**STATE OF NEW MEXICO
ENERGY, MINERALS AND NATURAL RESOURCES DEPARTMENT
OIL CONSERVATION DIVISION**

APPLICATIONS OF CIMAREX ENERGY CO. FOR COMPULSORY POOLING, LEA COUNTY, NEW MEXICO

NOTICE OF CIMAREX'S POST-HEARING EXHIBIT SUBMITTAL

- Replacement Land Slides B-6 and B-9: Revised to update the ownership information in the SW/4, to remove the pre-trade information, and to reflect Cimarex's acreage after the trade with ConocoPhillips. These two slides replace existing Land Slides B-6 and B-9.
- Replacement Geology Affidavit: Revised to correct certain errors in pre-filed testimony. The Replacement Geology Affidavit replaces the existing Geology Affidavit, which is Exhibit C.
- Replacement Reservoir Engineer Affidavit: Revised to correct certain errors in pre-filed testimony. The Replacement Engineer Affidavit replaces the existing Engineer Affidavit, which is Exhibit D.
- Replacement Engineer Slides D-12, D-13, D-14, and D-15-A: Revised to reflect addition of Devon Boundary Raider 712H well and updated well information. Replacement

Revised Tract Map/Ownership For Cimarex Coriander Units-Post Conoco Trade*

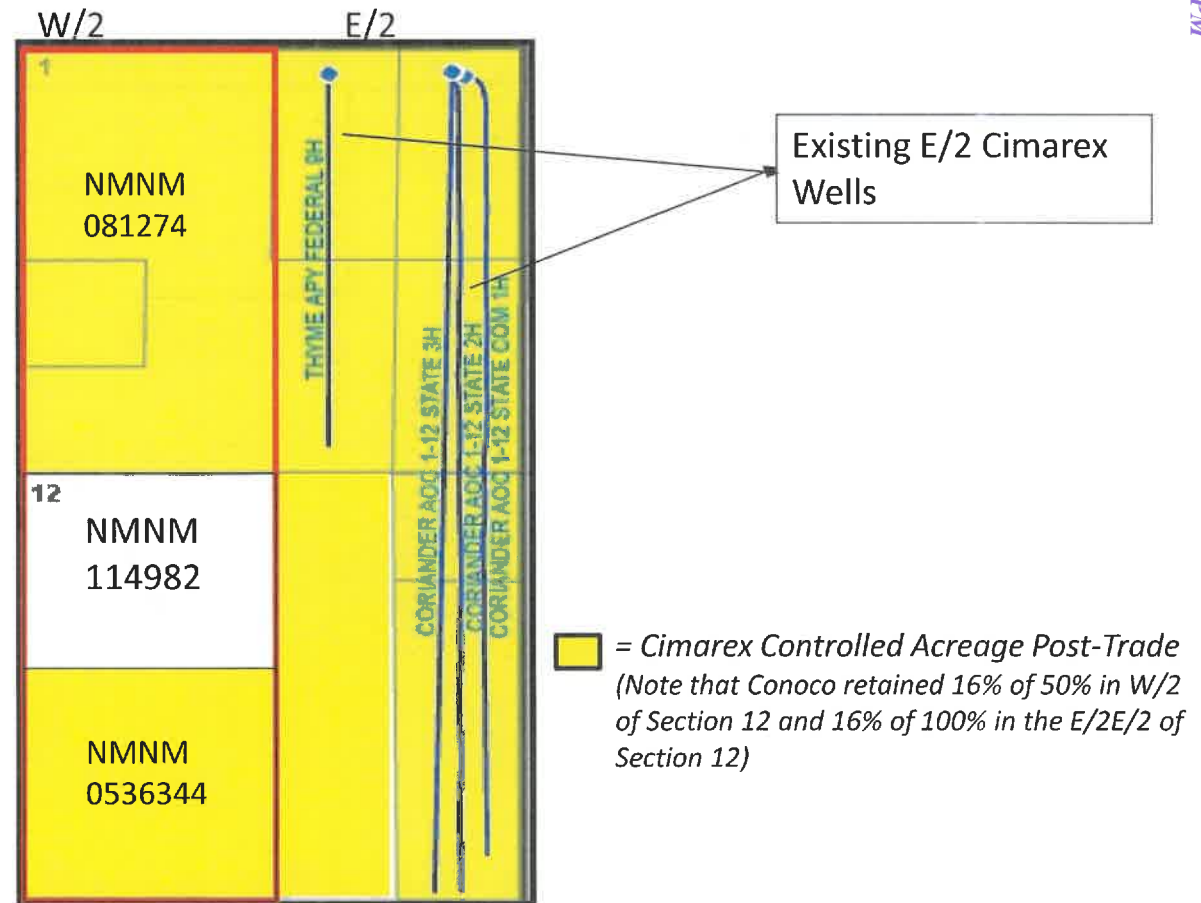
*Revised B-9: Revised to update ownership in SW/4 of Section 12 and to reflect Cimarex controlled acreage post-trade. Revisions in italics.

South Lea County Wolfcamp Well Count by Lateral Length - 720 sq. mile AOR

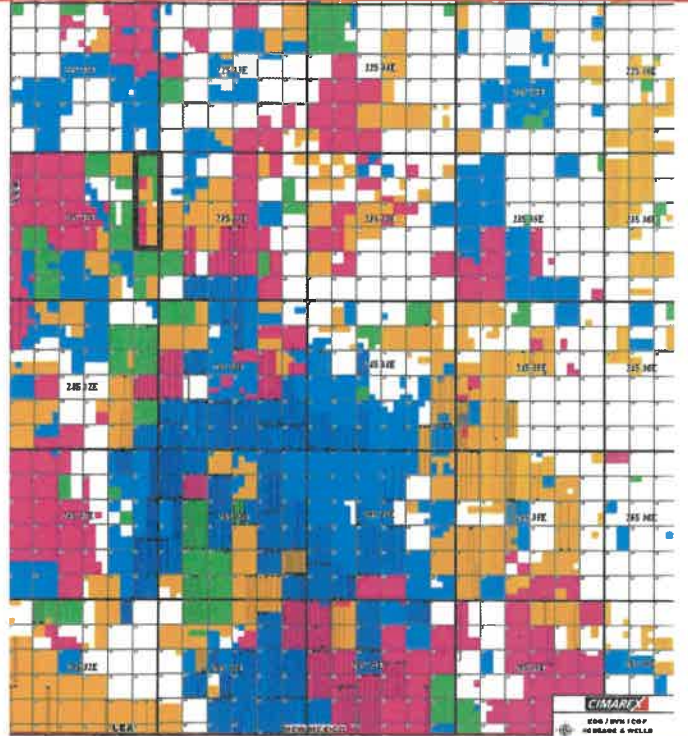
Engineer Slides D-12, D-13, D-14, and D-15-A replace existing Engineering Slides D-12, D-13, D-14, and D-15-A.

D-14

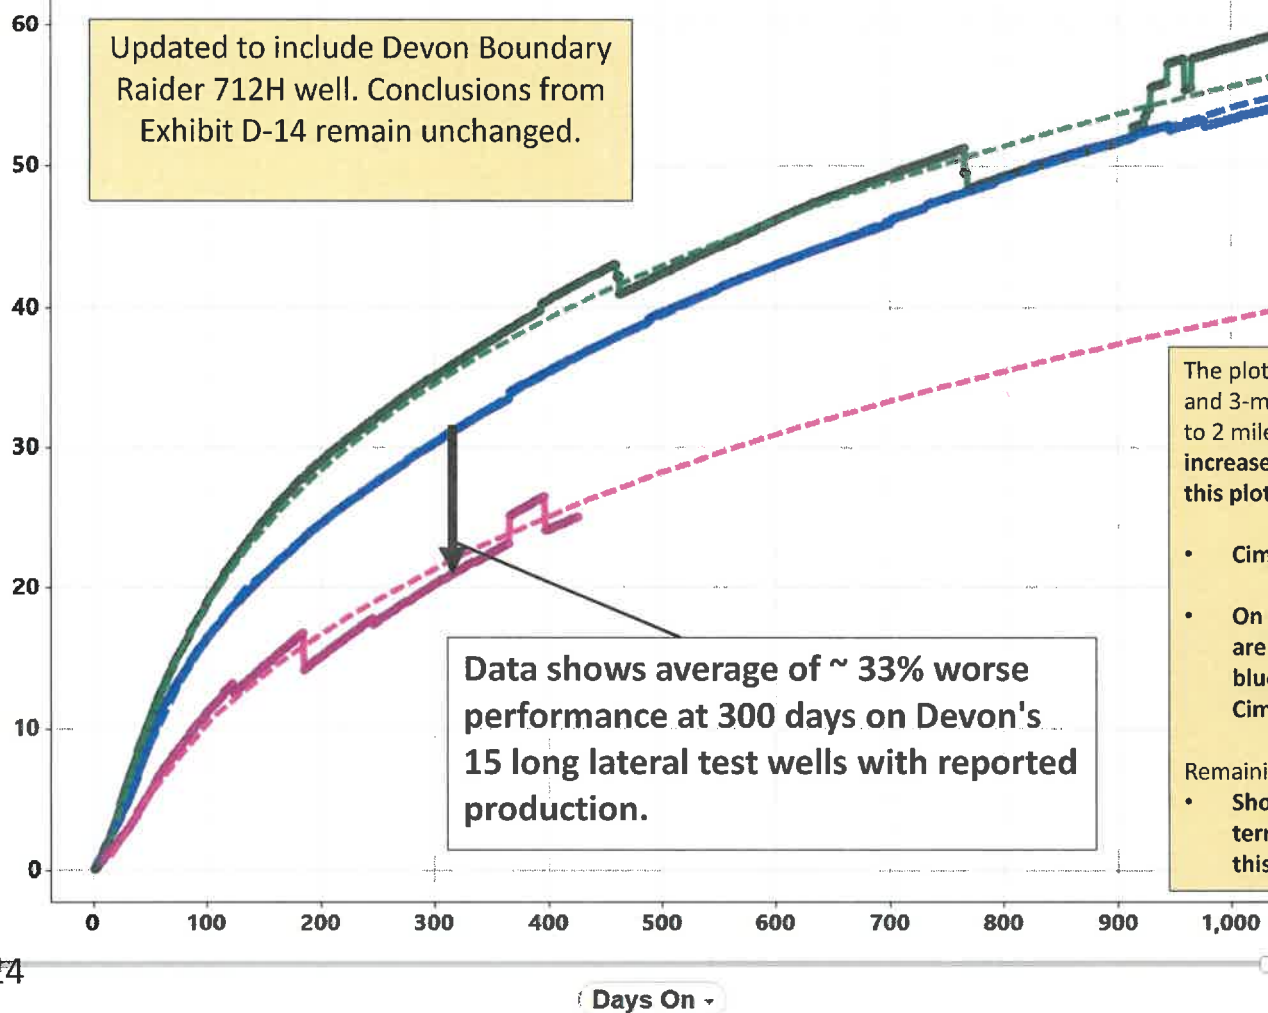
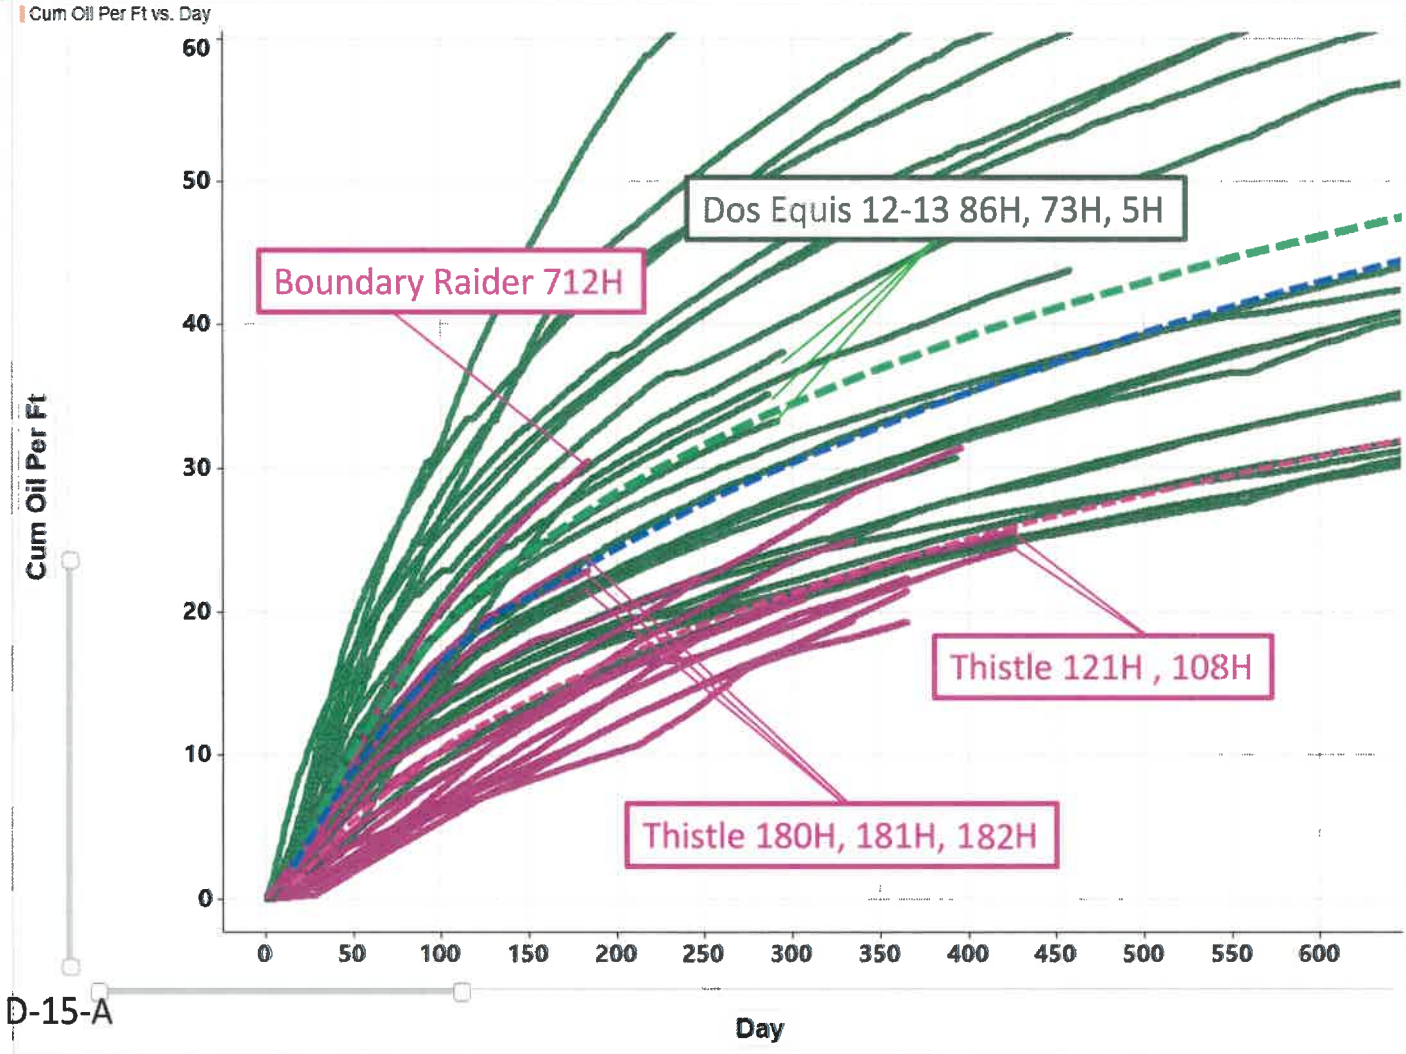
Updated to include Devon Boundary Raider 712H well. Conclusions from Exhibit D-14 remain unchanged.

Updated to include Devon Boundary Raider 712H well.
